## **13.0 Responses to TAC/Public Review**

**FLOODWAY EXPANSION PROJECT**

**ERRATUM**

PROJECT NAME: Floodway Expansion Project Environmental Assessment

Chapter 7 (Figure 7.2-1)

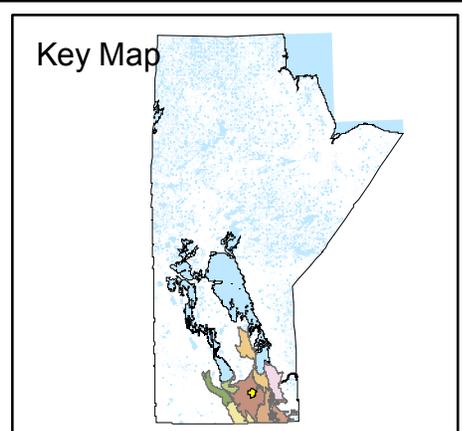
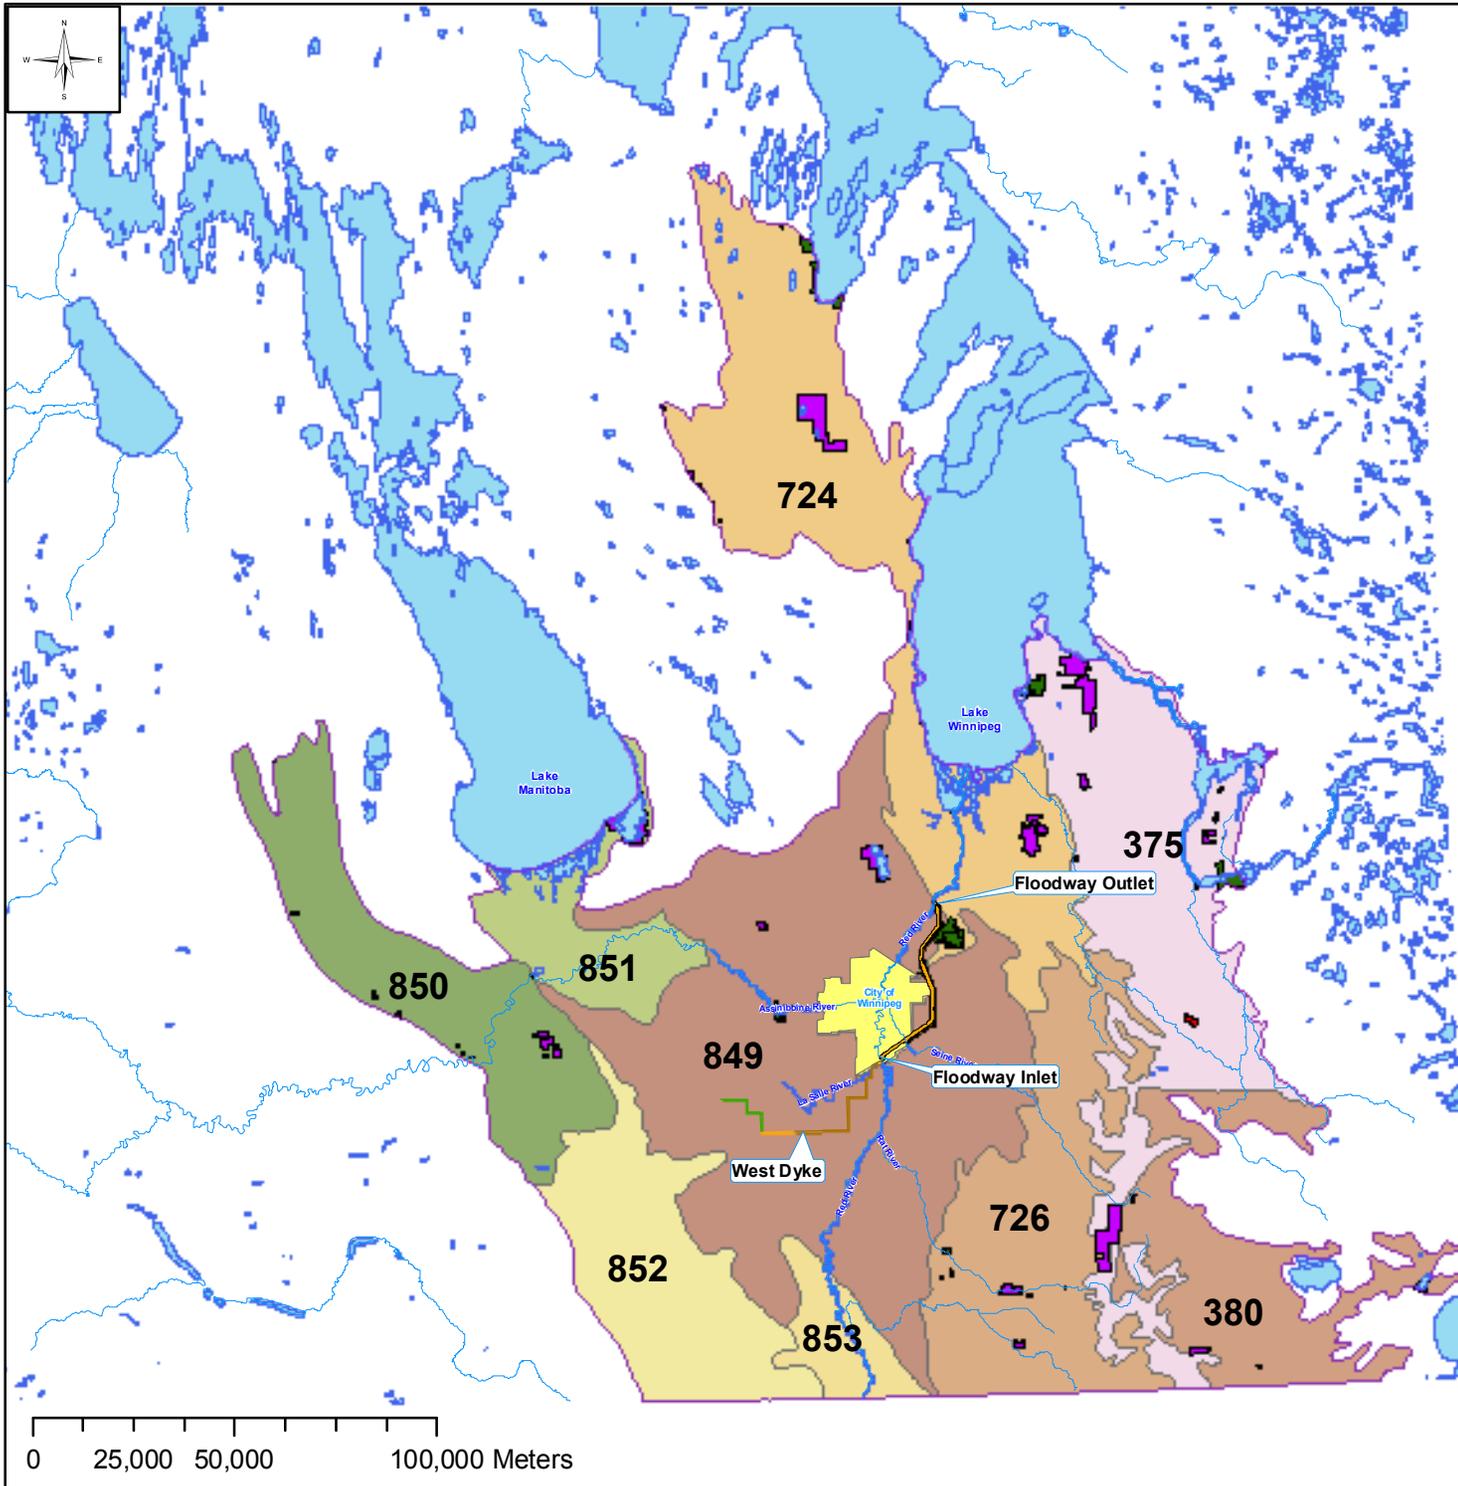
**DELETE** Figure 7.2-1 and **REPLACE** with the attached new Figure 7.2-1
